**Vieux Carré Commission
Architecture Committee Meeting**

Thursday, June 16, 2022

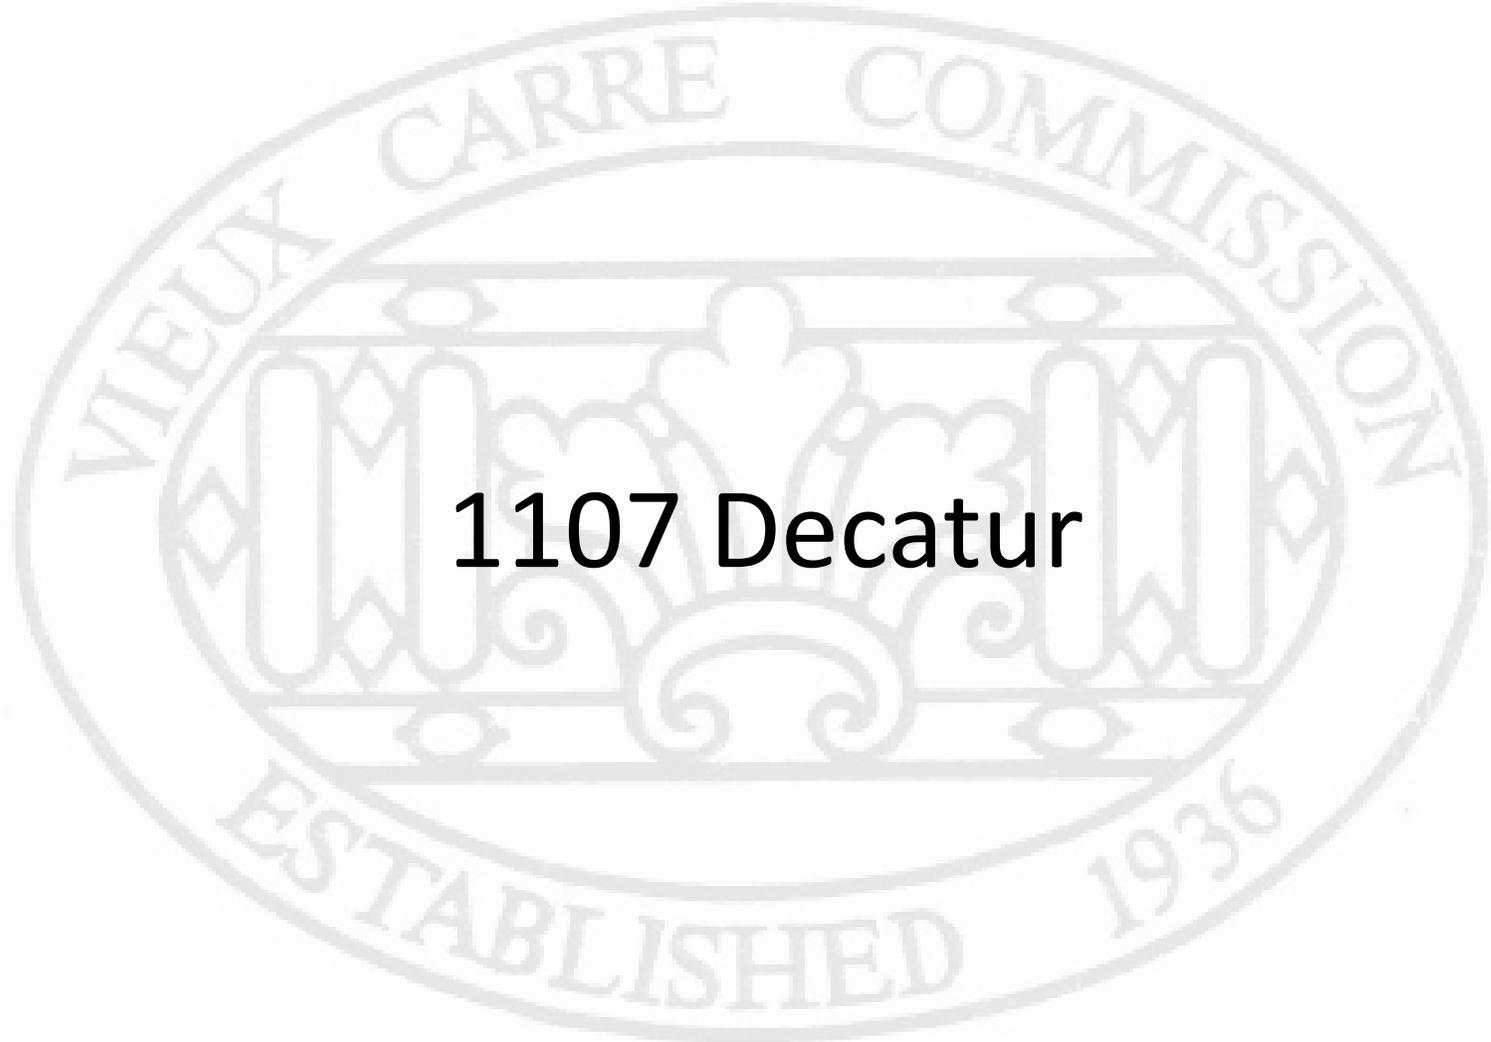
There is currently cap flashing in place on the parapet wall shared with 1107 Decatur and the one shared with 1113 Decatur. Photographs provided by the applicant show the current cap flashing as rising about 12” above the roof surface and being 12” wide. Interestingly, it looks like the cap flashing was installed on top of the slate rather than extending underneath the slate. As such, there is likely another layer of flashing installed below the slate or this installation technique may be to blame for any water intrusion that may be experienced in the building.

As this proposed cap flashing is in conjunction with an entire new roof installation, staff feels it is an opportune time to get this detail correct and it appears there is an adequate amount of parapet present to allow for a more approvable detail. Staff recommends denial of the proposed cap flashing.
